LAKEWINDS SOUTH ELEVATION
1/8" = 1'-0"

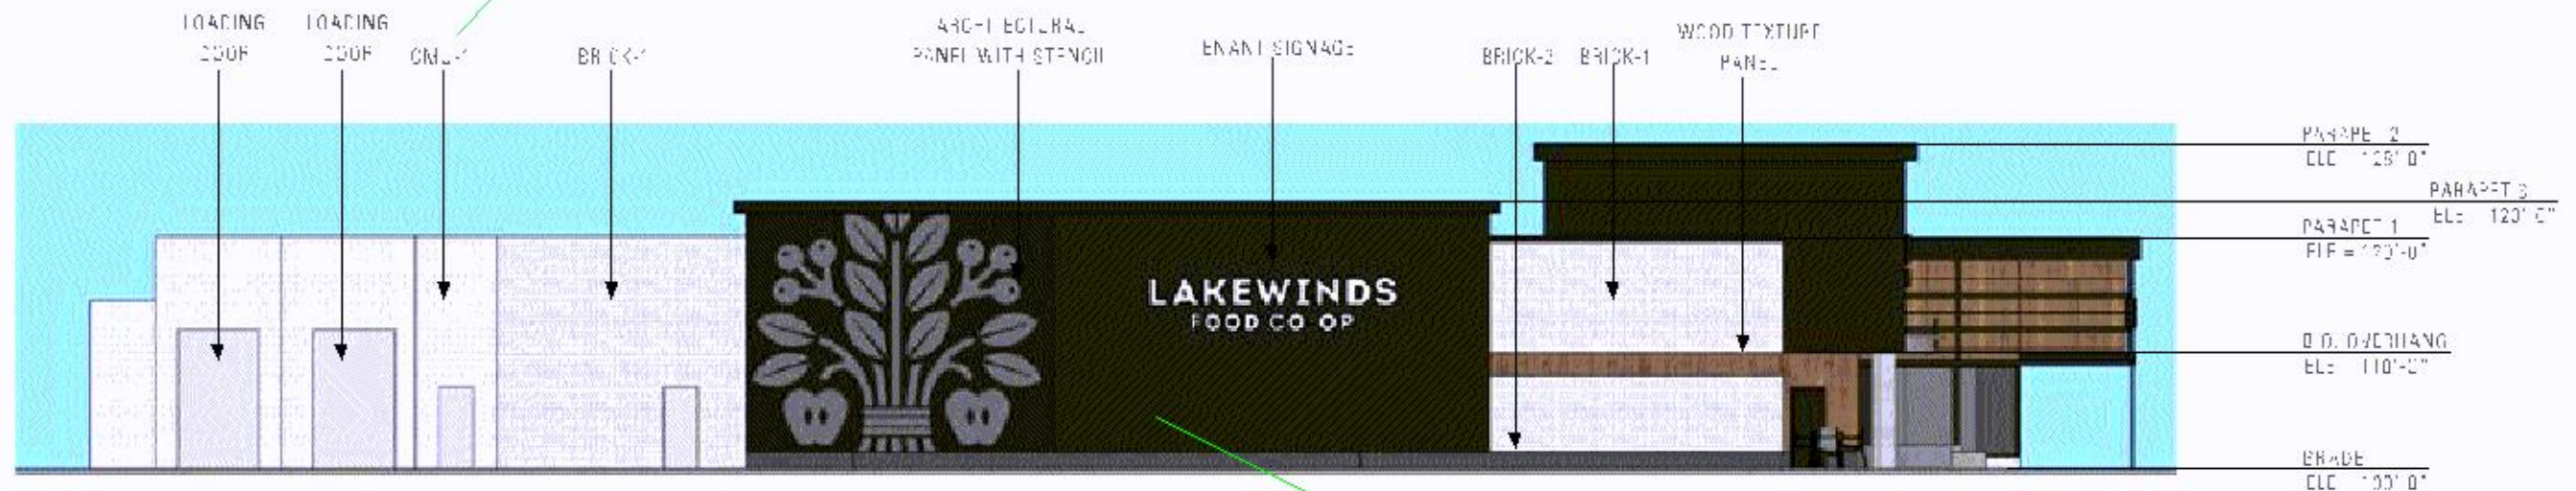
CMUs are not a permitted exterior building material. Select brick as the proposed building material or request a deviation to allow a split-faced CMU. Staff would need to evaluate the merits of that deviation from exterior materials standards.

The north building elevation was not included in the submittal. What is proposed for the north elevation?

LAKEWINDS WEST ELEVATION
1/8" = 1'-0"

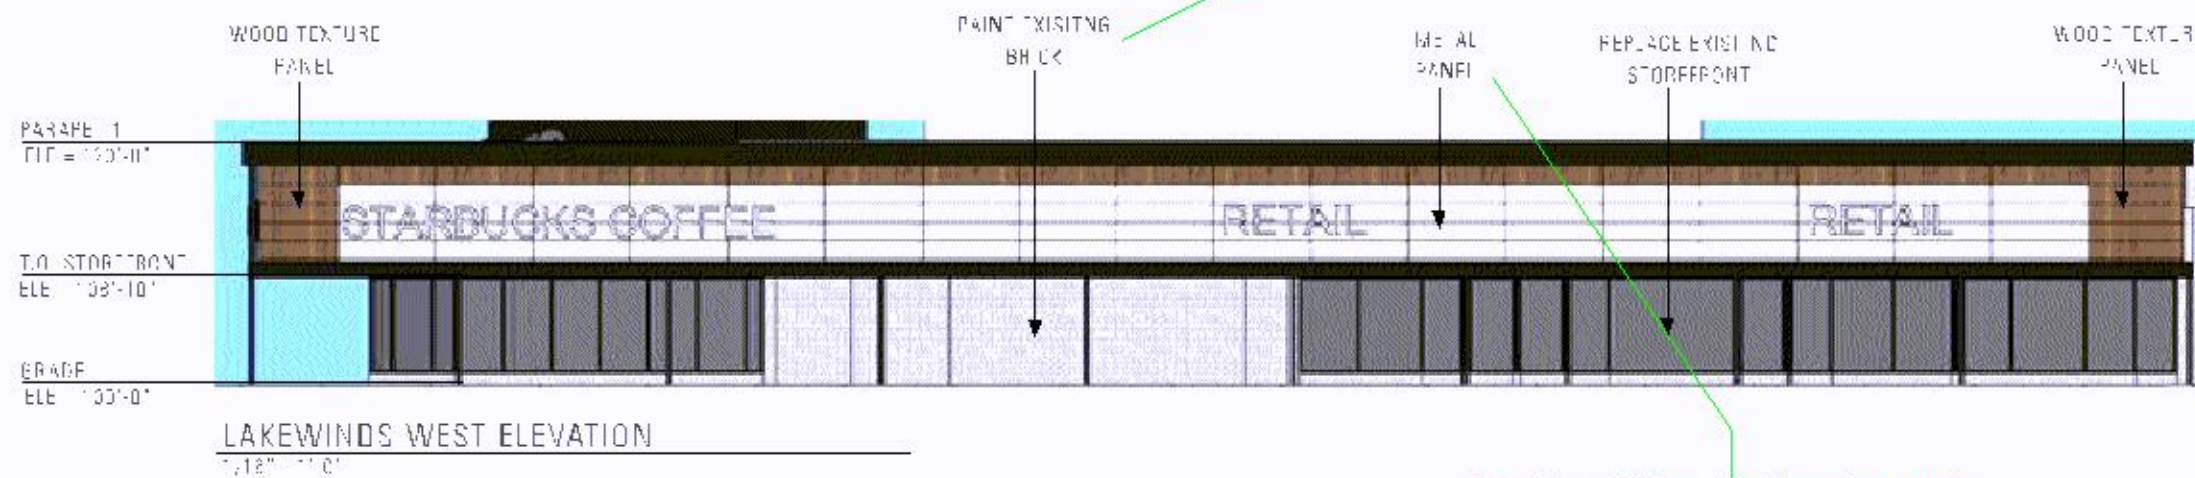
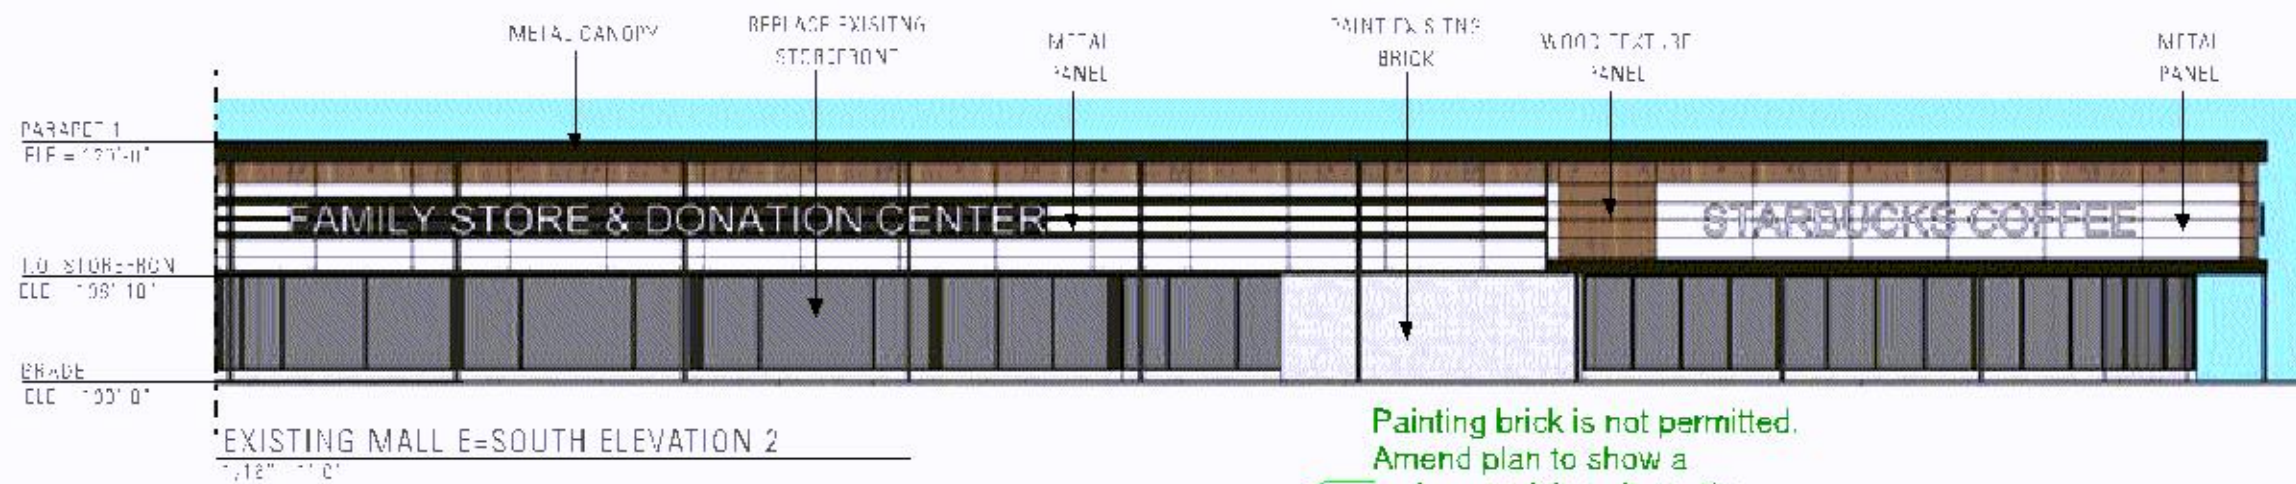
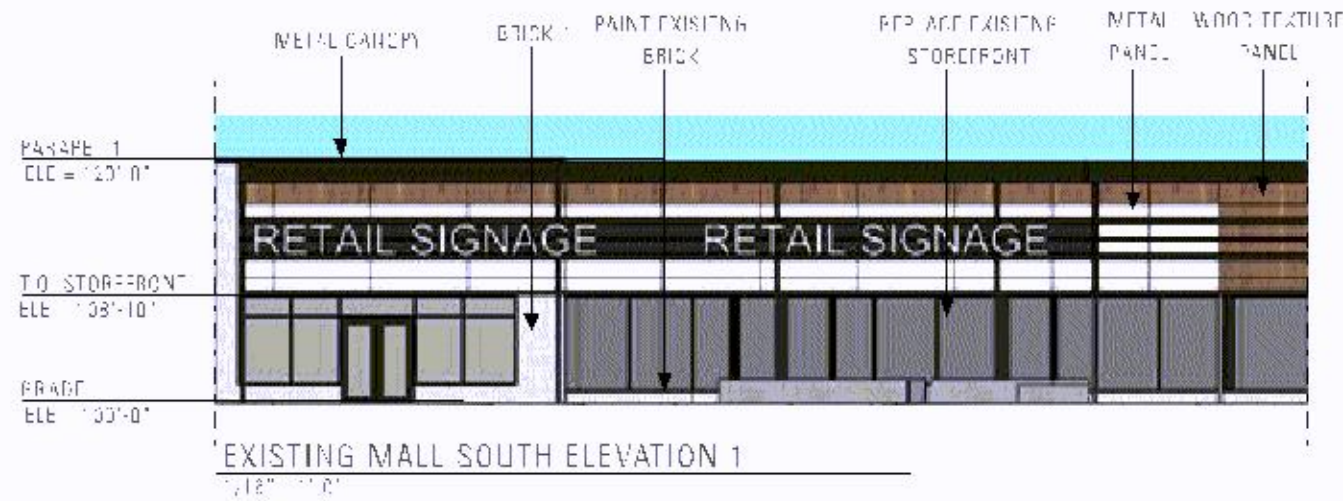
Are the "architectural panels fiber cement panels? If so, they are limited to 15 percent of a given building elevation.

Painting brick is not permitted. Amend plan to show a code-complying alternative.

Provide additional information on the proposed metal panels. There are panel thickness and durability requirements. Specifically, the City requires a minimum 30-year manufacturer finish warranty.
